# 183 – 205 E PALM STREET LAND USE MEETING 8/1/17

16 Single Family Residences

## **PSARA CORRESPONDENCE**

# PROPOSED SITE PLAN

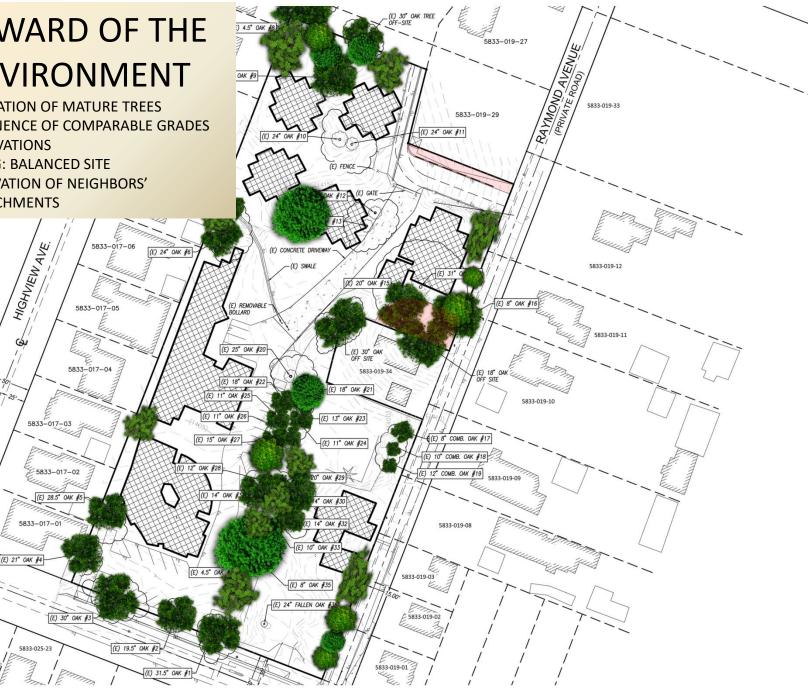
CONSERVATION OF NEIGHBORS' -**ENCROACHMENTS**

-NEW HOMES TO MEET OR EXCEED **REQUIRED SIDE AND REAR** SETBACKS OF 23' AND 35' - SUBTLE GRADE CHANGES FROM EXISTING - LEFT SIDE HAS BEEN DESIGNED TO **REFLECT THE HOMES ON** HIGHVIEW -RIGHT SIDE MORE CLOSELY **REFLECTS THE HOMES ON** RAYMOND
